712 Holly Avenue  
Takoma Park

HAWP 37/3-095

**From:** Holt Jordan [holt@jordanhoneyman.com]  
**Sent:** Monday, July 26, 2010 12:53 PM  
**To:** Fothergill, Anne  
**Cc:** 'Kowalczyk, Paula'  
**Subject:** RE: Requested stone change  
**Attachments:** IMG\_1359.jpg; IMG\_1360.jpg

- 1) Relocate the new shed slightly to meet setbacks and extend fence slightly to new shed location (see 5/18/2009 site plan and 4/12/10 site plan update).
- 2) Repair/rebuild the stone retaining wall in front of the house that was recently badly damaged when a snow plow struck a nearby fire hydrant. Plans and details are in the attachments and in the email below (one change noted in the new plan is the wall has bluestone coping).
- 3) Replace existing timber wall along driveway with masonry wall to match the existing wall.

proposed stone

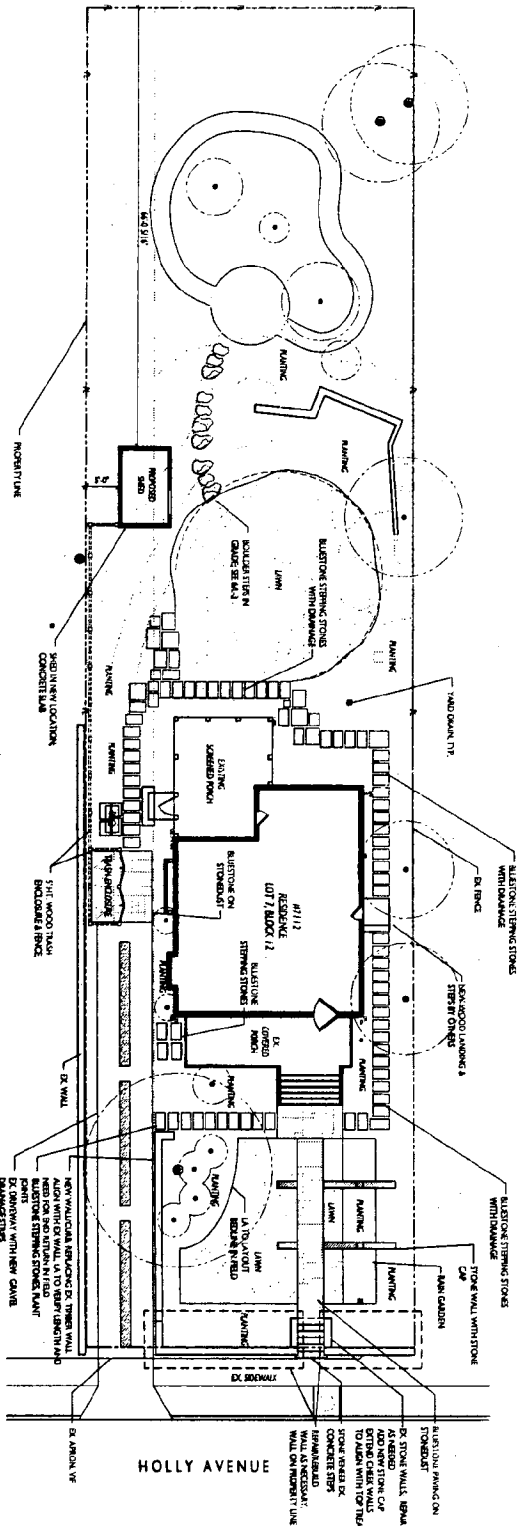
As I mentioned, we are requesting a stone change for the existing stone wall.

The original approval was for landscaping that included the repair and rebuilding of an existing front wall along Holly Ave. The re-built wall is in the same location as the original. During the snow storms this past winter, a snow plow hit a fire hydrant in front of the wall. The resulting pipe breakage created a sink hole about 6-8 feet deep in front of and behind the existing wall undermining about 15 linear feet of the existing wall and taking out the front city sidewalk too. A structural engineer was consulted and we have to totally rebuild this existing wall. Since we have to rebuild the wall we would like to take the opportunity to change the original stone to a Western Maryland wall stone. This new wall stone will be more harmonious with the new bluestone walk as well as match the stone wall and weirs that are approved and will be installed in the front yard rain garden. We have also used the Western Maryland Stone or the similar Pennsylvania wall stone in several projects in Takoma Park's Historic district; the closest being three doors down at 7204 Holly Avenue. We are also requesting that we eliminate the bluestone coping shown on our details since it was originally designed to help inhibit the further decline of the existing wall and will also provide a simpler design solution.

I've included a couple of snapshots, one of the existing wall and another at 7204 Holly Avenue where we used the Western Maryland wall stone.

4 STONE RETAINING WALL  
SECTION  
SCALE: 1/2" = 1'-0"

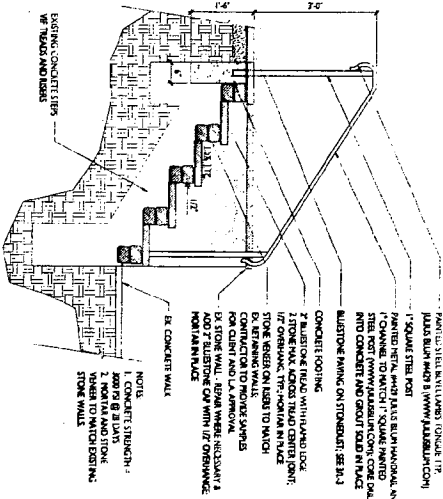
*no bluestone coping*

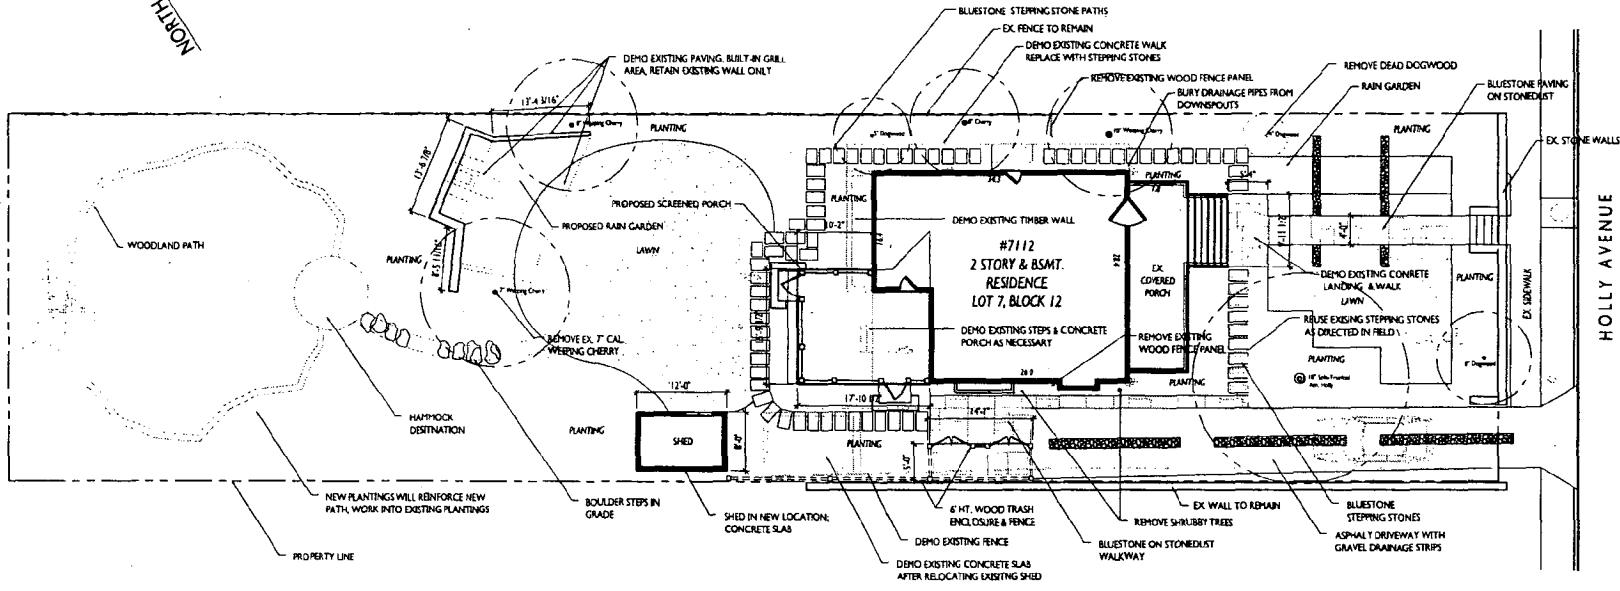
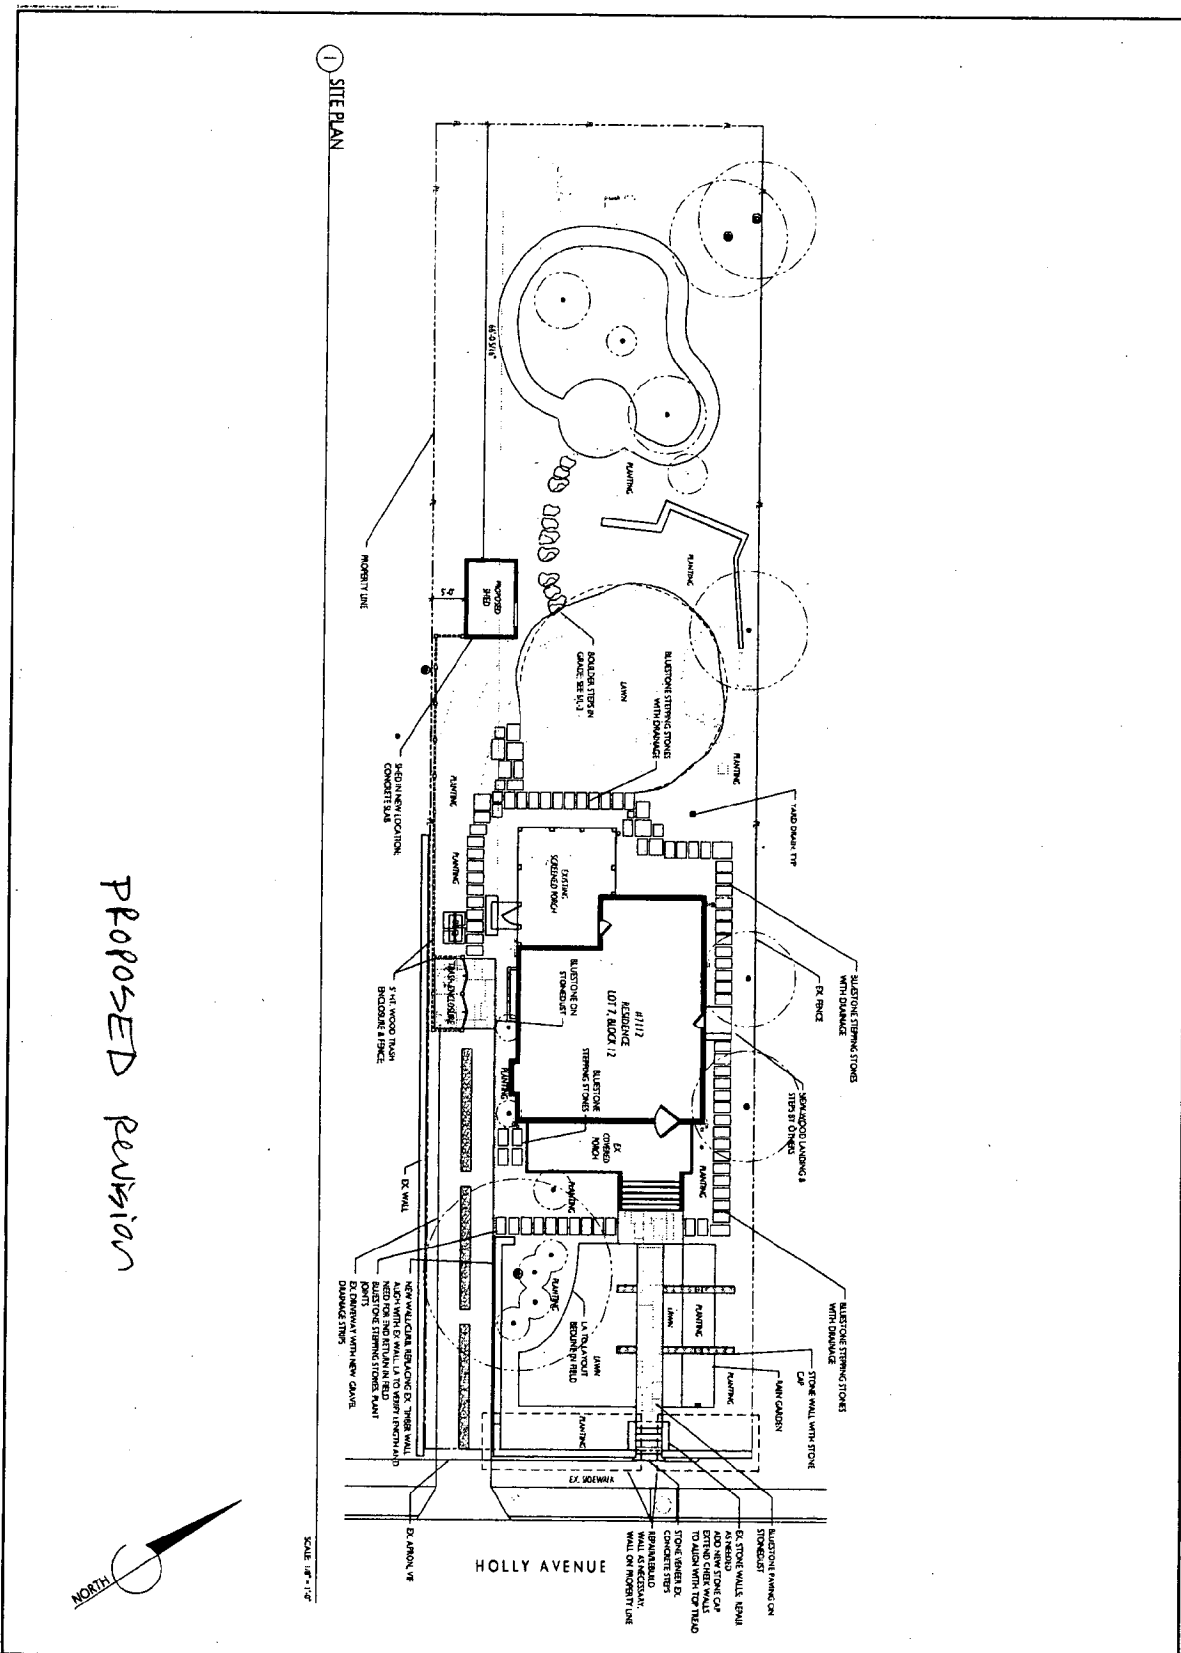
The applicant at 7112 Holly is proposing three revisions to their approved HAWP:

- another site plan with the relocated shed and wall-rebuilding area called out but also with all of the other information that was shown on the site plan that was originally approved.

Approved  
4/14

9 STONE RETAINING WALL REPAIR  
SCALE: 3/4" = 1'-0"

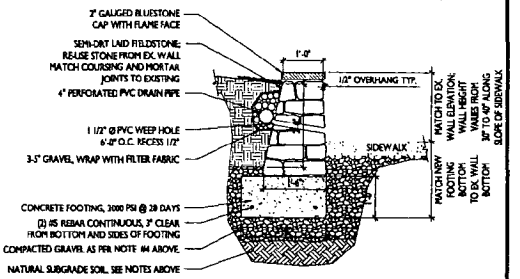
- a PDF of our detail sheet L-3; detail 9 shows the engineer-approved detail for rebuilding the wall.
- a pre-damage Google Maps street shot of the front of the property. The section of the wall that was damaged is to the left in the image; the section to the right of the stairs is the part we would like to rebuild depending on how well we are able to match it when the left side is rebuilt.

NOTES ON REPAIR/REBUILDING OF DAMAGED WALL:  
1. REMOVE ALL GRAVEL CURRENTLY FILLING EXCAVATION AND STOCKPILE FOR LATER USE.  
2. DEEPEN PORTION OF EXISTING WALL THAT IS NO LONGER SUPPORTED AND CLEAN/SAVE STONES FOR REUSE.

3. CLEAN EXCAVATION OF ALL ADDITIONAL LOOSE FILL, LUMBER, TREE ROOT MASS AND ANY OTHER DEBRIS TO EXPOSE UNDERLYING NATURAL SUBGRADE SOILS.  
4. FILL EXCAVATION WITH STOCKPILED GRAVEL TO DEPTH NECESSARY FOR INSTALLATION OF NEW CONCRETE FOOTING AS SHOWN BELOW. GRAVEL SHOULD BE PLACED IN LIFTS NOT EXCEEDING 8 INCHES IN THICKNESS AND COMPACTED WITH A MECHANICAL COMPACTOR TO NOT LESS THAN 95% OF THE MAXIMUM DRY DENSITY AS DETERMINED BY ASTM D1557. THE MOISTURE CONTENT OF THE GRAVEL SHOULD BE WITHIN 2% OF THE OPTIMUM MOISTURE CONTENT AS PER ASTM D1557.

5. CONTRACTOR TO HIRE A LICENSED GEOTECHNICAL ENGINEER OR CERTIFIED TESTING AGENCY TO VERIFY THE GRAVEL FILL HAS ACHIEVED THE COMPACTION SPECIFIED ABOVE.

6. MATCH BOTTOM OF NEW FOOTING TO BOTTOM OF EXISTING WALL.  
7. BATTER REAR OF MASONRY WALL FROM 12" AT TOP TO 18" WIDE AT BASE.
